Countries: CANADA, UNITED STATES **Document ID:** IK0700097
Availability: ISIS, Bus ISIS, FleetISIS, IsSIR **Revision:** 0
Major System: EXHAUST **Created:** 7/14/2017
Current Language: English **Last Modified:** 9/22/2017
Other Languages: NONE **Author:** Keith Kierzek
Viewed: 2882

Title: NEW Ultrasonic DEF Tank Sending Unit

Applies To: All SCR Vehicles

Figure 4: DEF tube orientation of 5/15 gallon float/optical sensor

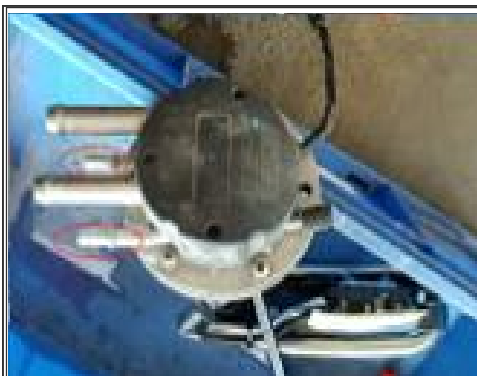
If a float and optical DEF sending unit is replaced with an ultrasonic DEF sending unit on 5 and 15 gallon tanks, the DEF lines **MUST** be replaced. Without replacing the DEF lines, the DEF sending unit will not fit in its original location due to different DEF supply and return tube orientation. Refer to Images 4 and 5 below to see the differences in DEF tube orientation.
